RE: 5637 East Mercer Way – Parcel #1924059312
City of Mercer Island, Washington
SWC Job#14-206

This letter is a response to your September 23, 2019 email to Bill Summers regarding permitting related to Parcel #1924059312.

CRITICAL AREA ENHANCEMENT PLAN
 - MI TREEHOUSE LLC -

5637 EAST MERCER WAY
 MERCER ISLAND, WASHINGTON

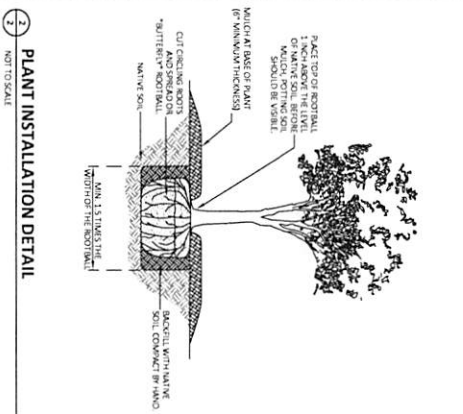
Permanent wetland impacts have decreased since the original 2015 design submittal. In addition, all temporary wetlands impacts are now categorized as permanent. Wetland impacts will be addressed when the applicant identifies an offsets mitigation opportunity, whether that is permittee-responsible or use of the King County Mitigation Reserves Program. Relocation of the building has increased the extent of wetland and stream buffer impacts, while reducing direct wetland impacts. The onsite buffer enhancement plan was expanded compared to previous submittals; however, it is unclear if the applicant has mitigated at a 1:1 mitigation ratio, as typically required by local regulations. The applicant should confirm that their buffer mitigation plan achieves the 1:1 buffer mitigation standard.

Response: The latest revised mitigation plan mitigates for buffer impacts at a ratio of 1:1 as requested with enhancement.
